SUBJECT: Forwards info needed to evaluate environ qualification program, in response to NRC 800109 request. Excerpts from FSAR encl. Addl info was provided in FSAR Amend 13.

Subject: Docket Nos. 50-361 and 50-362  
San Onofre Nuclear Generating Station  
Units 2 and 3

# ENVIRONMENTAL QUALIFICATION INFORMATION LIST

## SAN ONOFRE UNITS 2 and 3

<p><b>SAN ONOFRE</b>  <b>NUCLEAR GENERATING STATION</b>  Units 2 &amp; 3</p>
<p>MAIN STEAM AND FEEDWATER  ENCLOSURE (NORTH) PLAN &amp; SECTION  EL 43'-0" TO 61'-6"</p>
<p>Figure 010.47-1</p>

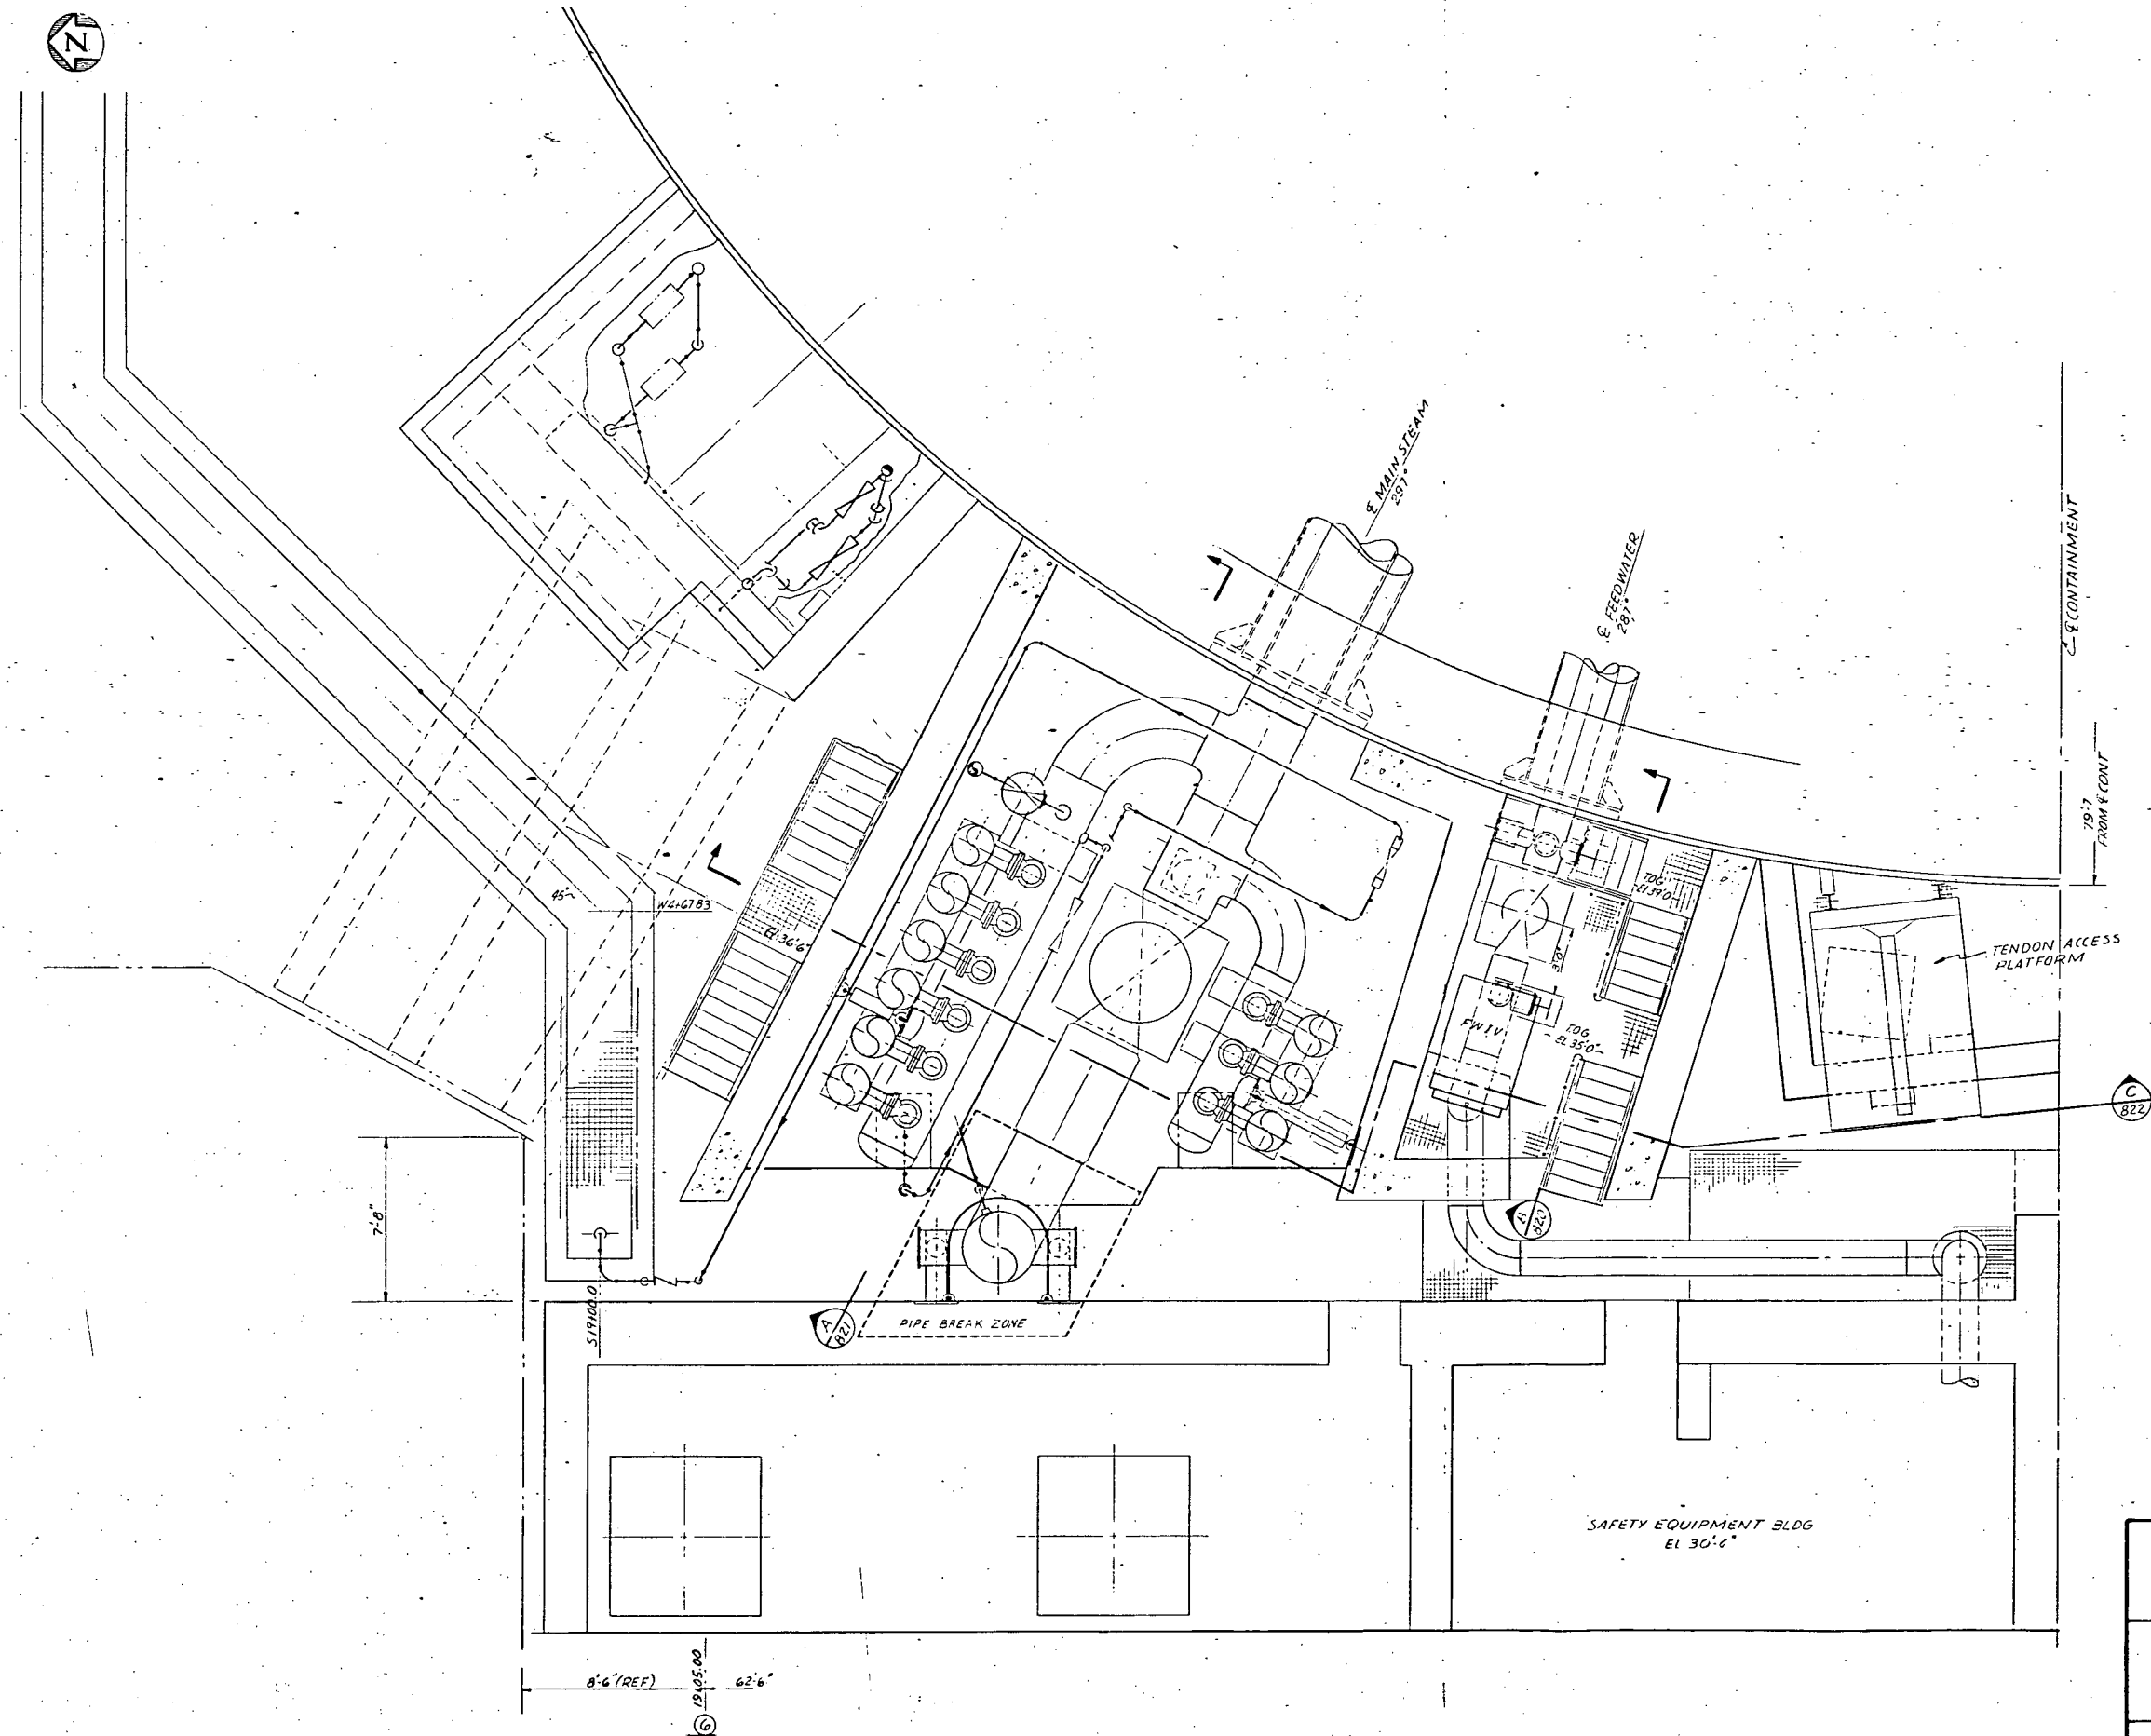
Figure 1.2-12 of the FSAR shows a main steam and feedwater line valve room adjacent to the reactor building. For safety, we require the valve room be designed to withstand the environmental effects of a main steam or feedwater line break equivalent to the flow area of a single ended pipe rupture, e.g., by venting. In conjunction with the above, we require the applicant to provide a subcompartment pressure analysis to confirm that the valve room as designed will withstand the environmental effects of a break in this area. In addition we require the applicant to qualify any equipment including the main steam isolation valves and operators, located in the valve room and required for safe shutdown. Such equipment must be capable of operating in the resulting environment.

11 The San Onofre 2&3 design provides two physically separated main steam and feedwater valve rooms per unit. FSAR figures 1.2-3 and 1.2-4 show this physical separation. Each of the main steam and feedwater valve rooms contain one train of main steam and feedwater piping. The only safety-related components in these rooms are the main feedwater isolation valves, main steam isolation valves, main steam isolation bypass valves, auxiliary feedwater isolation valve, steam line safety-relief valves, and steam dump valves associated with the particular safety train in these rooms. The main steam and feedwater valve rooms have been designed and constructed to withstand the environmental effects of a main steam or feedwater line break in that room. The main steam line break is the limiting break. figures 010.47-1 through 010.47-5 show the main steam line break zones used to establish the building design. Vent areas and blowout panels in the building dissipate the shutdown energy. Safety-related components that are required for safe shutdown are being qualified to the environmental conditions resulting from the limiting pipe breaks described above.

See FSAR sections 3.6 and 6.2; figures 1.2-3, 1.2-4, and 010.47-1 through 010.47-11; and tables 010.47-1 through 010.47-5. No FSAR change was made.
